SUBJECT: SALEM AND HOPE CREEK GENERATING STATIONS - FOLLOW UP  
INSPECTION FOR POTENTIAL INADEQUACY OF SIMULATOR TESTING -  
INSPECTION REPORT NOS 05000272/2004007; 05000311/2004007;  
05000354/2004007

Report Nos: 05000272/2004007; 05000311/2004007; 05000354/2004007

Facility: Salem and Hope Creek Generating Stations

**Figure 1, Containment Sump Level**

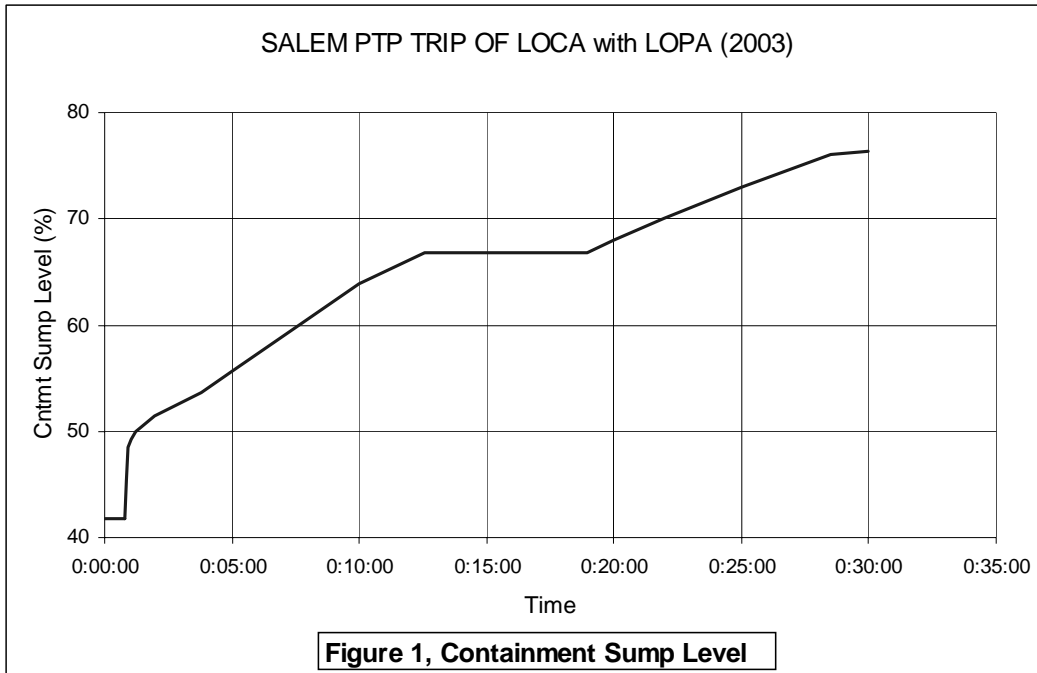
During review of simulator transient test data, the NRC identified a potential simulator fidelity/negative training issue. Inspectors questioned the indicated plateau in containment sump level during the injection phase of a large break loss of coolant accident simulation (see Figure 1). The plateau is observable in the Loss of Coolant Accident (LOCA) With Loss of Power (LOP) annual transient test results. It was determined that the plateau is based on the station's containment flood analysis.

A review of this calculation (Containment Volume Vs. Flood Level Analysis Design Calculation S-C-A900-MDC-0082, Rev. 1) shows that the plateau is expected to begin when the sump level reaches 81 feet 9 inches (approximately 67% indicated) because any further water addition to the sump will spill over into the area that provides access to the reactor sump and reactor coolant drain tank (RCDT) areas. The indicated level is calculated to remain at 81 feet 9 inches until 92,730 gallons of water spills over, filling the reactor sump and RCDT areas. This calculation assumes the water spills over primarily through a wire mesh door that acts to block entry into the area of the stairway to the reactor sump. Photographs were obtained from Radiation Protection showing

that, while Unit 1 has a wire mesh door, Unit 2 actually has a metal plate door. The assumption used in the calculation, that water will flow un-impeded through the closed door, is apparently not correct for Unit 2, which is the reference plant for the simulator. PSEG generated a condition report (CR #70037479) to review and correct the calculation and the erroneous drawing which states the Unit 2 door is wire mesh construction. The response documented in the condition report indicates that alternate paths exist for water to travel to the reactor sump and RCDT areas, other than through the door. These paths were not credited in the original calculation.

During the exit meeting, PSEG personnel explained that they will expedite the corrective action to revise the calculation and will forward results to the NRC. This item is unresolved pending a review of the revised containment flooding calculation and the simulator sump level response. **URI 05000272, 311/2004007-04, Salem Simulator Fidelity Concern Regarding Containment Level Response to Flooding.**
